Addendum 93: Regulation No. 94

Revision 1 – Amendment 1

02 series of amendments to the Regulation - Date of entry into force: 23 June 2011

Uniform provisions concerning the approval of vehicles with regard to the protection of the occupants in the event of a frontal collision

Model B

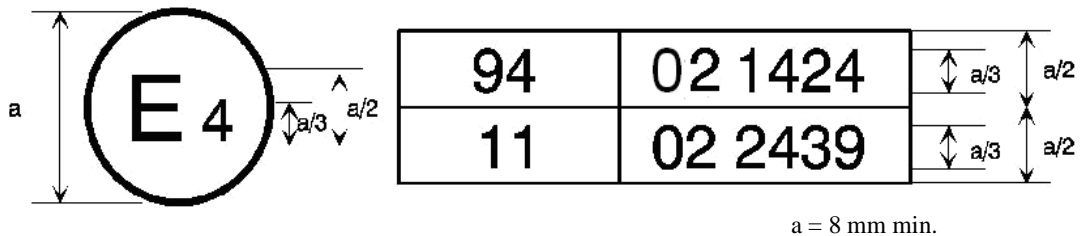
Annex 2, amend to read:

The above approval mark affixed to a vehicle shows that the vehicle type concerned has been approved in the Netherlands (E4) pursuant to Regulations Nos. 94 and 11¹. The first two digits of the approval numbers indicate that, at the dates when the respective approvals were granted, Regulation No. 94 incorporated the 02 series of amendments and Regulation No. 11 incorporated the 02 series of amendments."

Figure 1
Measurement of V_b , V_1 , V_2

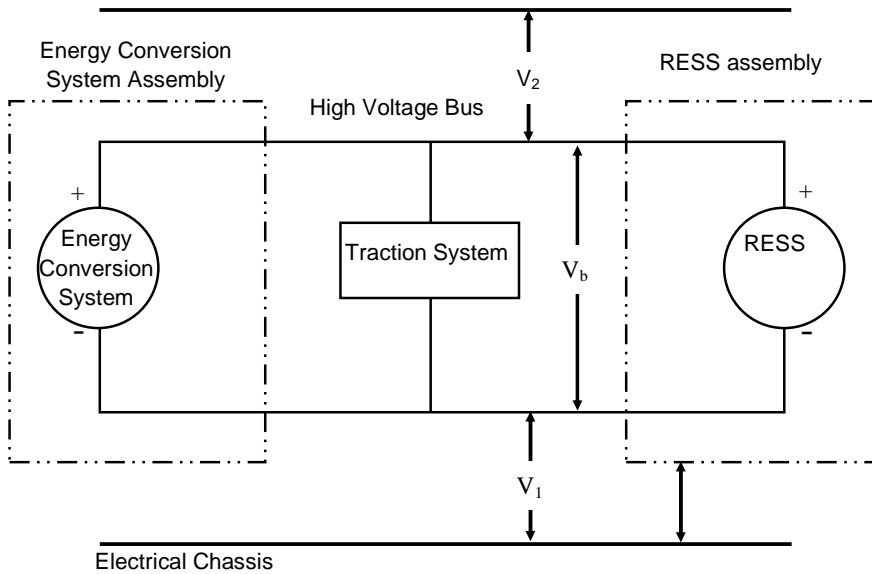
After the impact test, determine the high voltage bus voltages (V_b , V_1 , V_2) (see figure 1).

The voltage measurement shall be made not earlier than 5 seconds, but, not later than 60 seconds after the impact.

Figure 2
 E.g. measurement of high voltage bus energy stored in X-capacitors

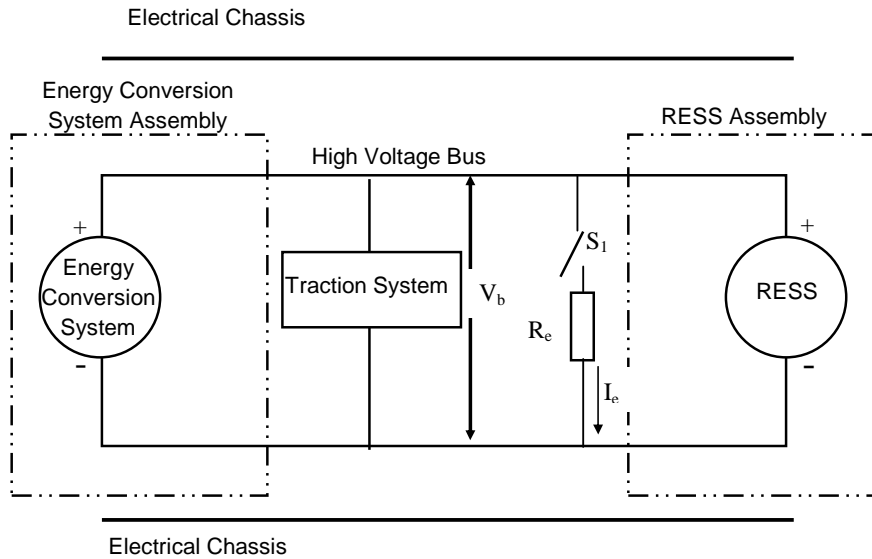
Prior to the impact a switch S_1 and a known discharge resistor R_e is connected in parallel to the relevant capacitance (ref. figure 2).

Not earlier than 5 seconds and not later than 60 seconds after the impact the switch S_1 shall be closed while the voltage V_b and the current I_e are measured and recorded. The product of the voltage V_b and the current I_e shall be integrated over the period of time, starting from the moment when the switch S_1 is closed (t_c) until the voltage V_b falls below the high voltage threshold of 60 V DC (t_h). The resulting integration equals the total energy (TE) in joules.

Figure 3
Measurement of V_1'

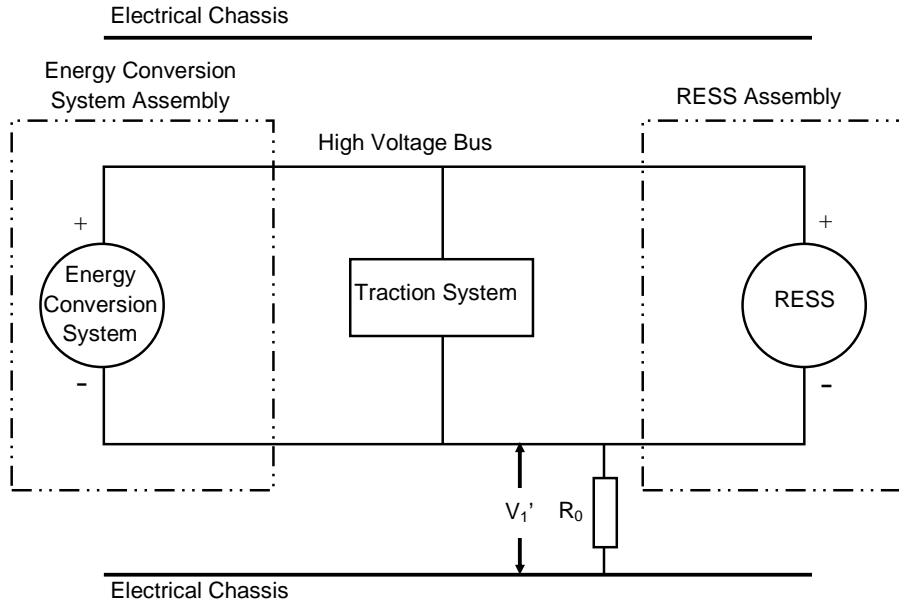
If V_1 is greater than or equal to V_2 , insert a standard known resistance (R_o) between the negative side of the high voltage bus and the electrical chassis. With R_o installed, measure the voltage (V_1') between the negative side of the high voltage bus and the vehicle electrical chassis (see figure 3). Calculate the isolation resistance (R_i) according to the formula shown below.

$$R_i = R_o * (V_b / V_1' - V_b / V_1) \quad \text{or} \quad R_i = R_o * V_b * (1 / V_1' - 1 / V_1)$$

Figure 4
Measurement of V_2'

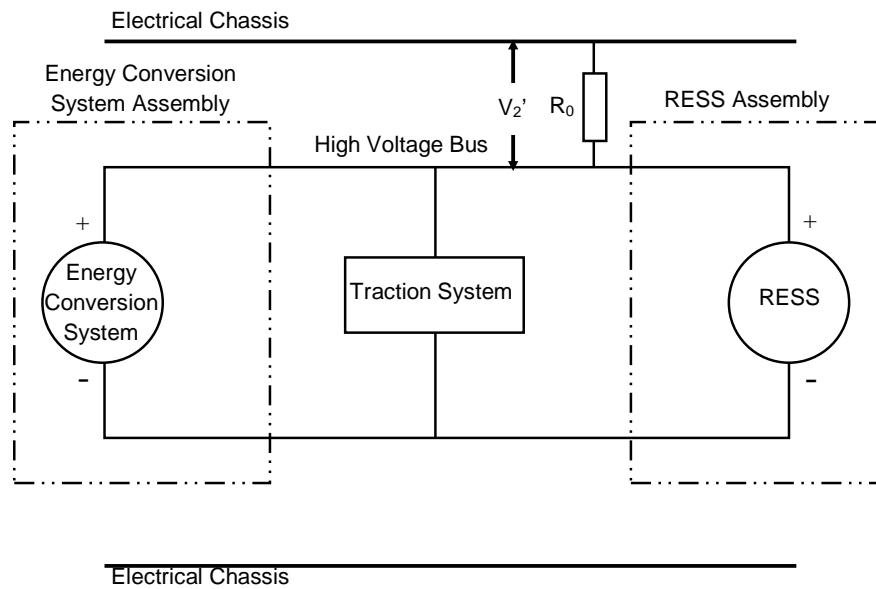
If V_2 is greater than V_1 , insert a standard known resistance (R_0) between the positive side of the high voltage bus and the electrical chassis. With R_0 installed, measure the voltage (V_2') between the positive side of the high voltage bus and the electrical chassis (see figure 4).

$$R_i = R_0 * (V_b / V_2' - V_b / V_2) \quad \text{or} \quad R_i = R_0 * V_b * (1 / V_2' - 1 / V_2)$$

Figure 1
 Jointed test finger

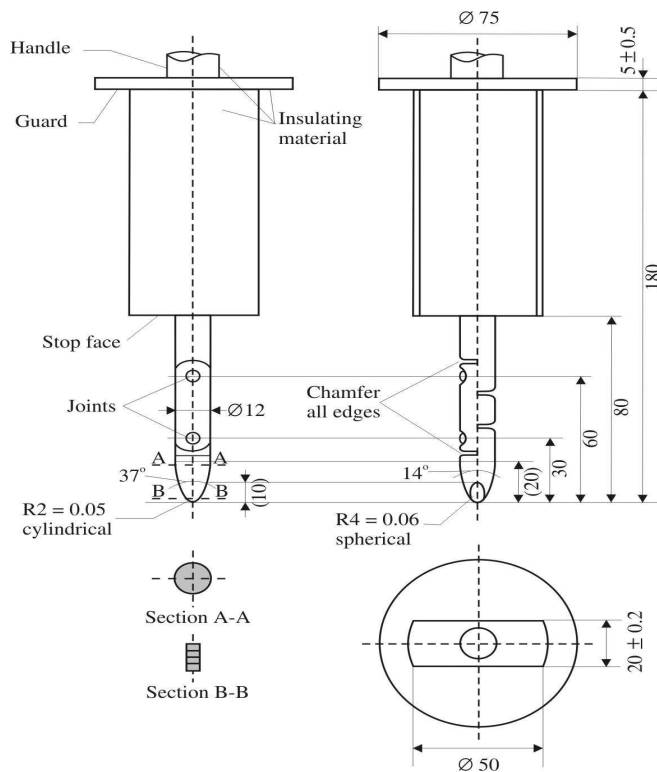
The Jointed Test Finger described in figure 1 of Appendix 1 shall be inserted into any gaps or openings of the physical protection with a test force of $10\text{ N} \pm 10$ per cent for electrical safety assessment. If partial or full penetration into the physical protection by the Jointed Test Finger occurs, the Jointed Test Finger shall be placed in every position as specified below.

Starting from the straight position, both joints of the test finger shall be rotated progressively through an angle of up to 90 degrees with respect to the axis of the adjoining section of the finger and shall be placed in every possible position.

Both joints shall permit movement in the same plane and the same direction through an angle of 90° with a 0 to $+10^\circ$ tolerance."
